APPLICATION NO.	FILING DATE	FIRST NAMED INVENTOR	ATTORNEY DOCKET NO.	CONFIRMATION NO.
10/616,418	07/09/2003	Craig P. Nadel	NN001USU	1280

Office Action Summary	Application No.	Applicant(s)	
	10/616,418	NADEL, CRAIG P.	
	Examiner	Art Unit	
	Troy Chambers	3641	NW

DETAILED ACTION

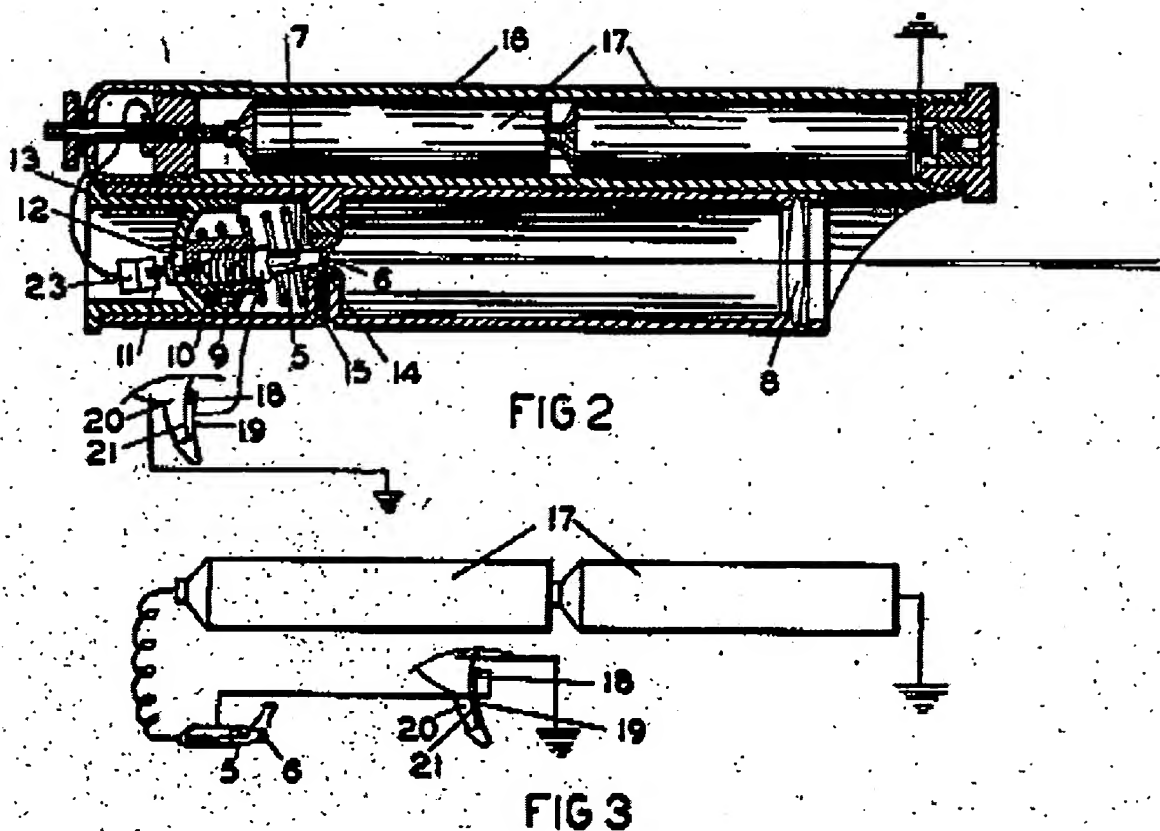
14. Claims 1-3, 10-15 and 21 are rejected under 35 U.S.C. 103(a) as being unpatentable over U.S. 5343850 issued to Steer in view of U.S. 2844710 issued to Zinsser. Steer discloses a projectile launcher as disclosed below.

With respect to claim 1, Steer discloses:

A projectile launcher	10
Elongated barrel	30, 40
Forcibly launching means (defined in claims 2 and 3)	20, 70

The pressurized air bellows 20 operates in response to a pulling of the trigger and is thus "hand operated". Although claim 1 recites the term "audiovisual", applicant has elected a species covering only a visual stimulus. Hence, with respect to the

However, Steer does not disclose the means for generating an audiovisual stimulus at about the same time as the launch of at least one projectile. Zinsser discloses such a means including a trigger-actuated (col. 2, ll. 33-43) light bulb 5 connected to batteries 17.

At the time of the invention, one of ordinary skill in the art would have found it obvious to provide the projectile launcher 5 with the trigger-actuated audiovisual stimulus of

Zinsser. The suggestion/motivation for doing so would have been to mark the spot at which the launcher would be directed.

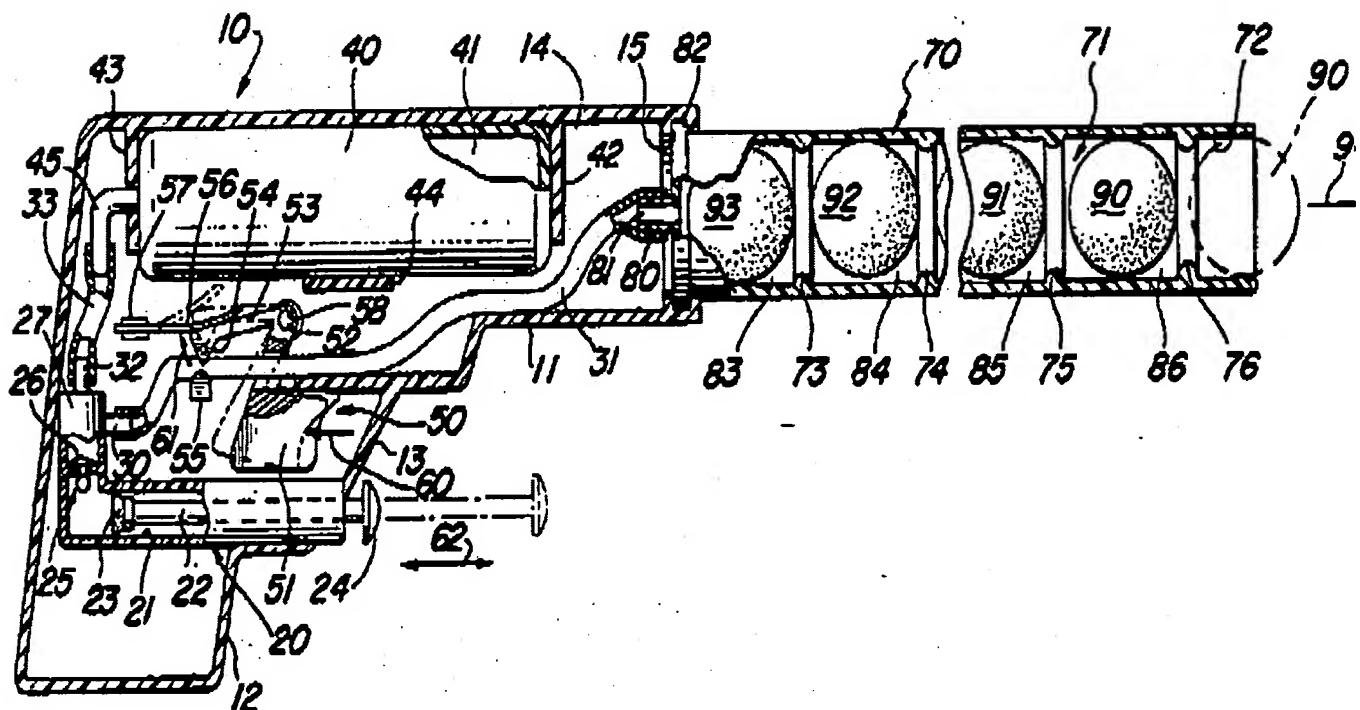
22. Claim 1-3, 8-15, 21 and 25 are rejected under 35 U.S.C. 103(a) as being unpatentable over U.S. 5343849 issued to Steer in view of Zinsser.

A projectile launcher	10
Elongated barrel	70
Forcibly launching means (defined in claims 2 and 3)	20, 25

23. However, Steer does not disclose the means for generating an audiovisual stimulus at about the same time as the launch of at least one projectile. Zinsser discloses such a means including a trigger-actuated (col. 2, ll. 33-43) light bulb 5 connected to batteries 17.

At the time of the invention, one of ordinary skill in the art would have found it obvious to provide the projectile launcher 5 with the trigger-actuated audiovisual stimulus of Zinsser. The suggestion/motivation for doing so would have been to mark the spot at which the launcher would be directed.
